Statement of Response to An Bord Pleanála Opinion

**Proposed Strategic Housing Development
(SHD) at Ratoath, Co. Meath**

BEO PROPERTIES LTD.

May 2022

Figure 2-1: Pedestrian and Bicycle Connectivity (Source: RKD)

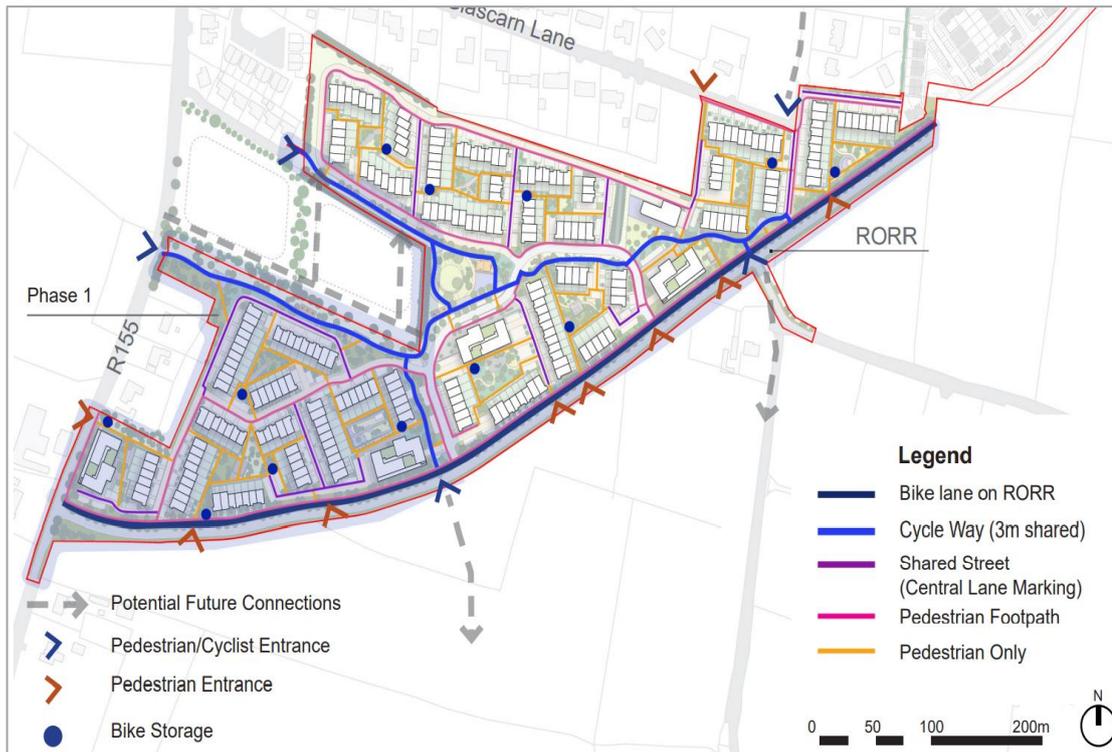
Further consideration and/or justification of the documents as they relate to the movement of pedestrians and cyclists from the subject site into Rathoath Village and surrounding area. The submitted documentation should demonstrate clear pedestrian and cycle connectivity and the timescale, phasing and delivery of any infrastructure associated with the proposed pedestrian and cycle connectivity, including any third-party consents required for the works. For the cycle facilities that are proposed, the specific compliance with the particular requirements of the National Cycle Manual should be demonstrated by the documents.

Response: The Board requested that the submitted documentation should demonstrate clear pedestrian and cycle connectivity and timescale phasing and delivery of any infrastructure associated with the proposed pedestrian and cycle connectivity.

The proposed development provides for a high level of permeability and connectivity throughout. An in-depth analysis of cyclist and pedestrian permeability and connectivity has been provided by RKD within their **Architectural and Urban Design Report** which is enclosed as part of this planning application. As shown on Figure 2-1 below the cycle network is developed based on the requirements of the National Cycle Manual including a central 3m wide cycleway and pedestrian path through the site that is off-road and remote from vehicular traffic. This central route offers high comfort levels and serves both commuter and leisure functions by connecting to the R155, Glascarn Lane and the RORR to access town.

With regard to the timeframe for the phasing and delivery of pedestrian and cyclist infrastructure associated with the proposed development, the first phase of the development will deliver three new cycle entrance points to the site and three pedestrian entrances with connections to both R155 and the RORR. This will allow cyclist and pedestrian connection to Jamestown SHD and Ratoath College from day one and tie in with MCC’s proposed extension to the pedestrian and bicycle infrastructure of Ratoath Village.

Furthermore, the Board requests that *“For the cycle facilities that are proposed, the specific compliance with the particular requirements of the National Cycle Manual should be demonstrated by the documents”*. The design is compliant with the National Cycle Manual and all details can be found within the documentation submitted by RKD and O’Connor Sutton Cronin Consultant Engineers (OCSC). A key objective within this cycle manual is to *“Provide for two abreast where possible for safety, visibility and attractiveness”*. The proposed development provides three types of bicycle routes within the development, all providing for two abreast cycling as noted below,

- Greenway Spine: 3m wide Cycle Way shared with pedestrians
- RORR: 3m wide bike path next to 2.5m footpath separated from vehicles with 1.5m hard margin
- Shared Streets: 5.5m wide road with lane separator and bicycle marking
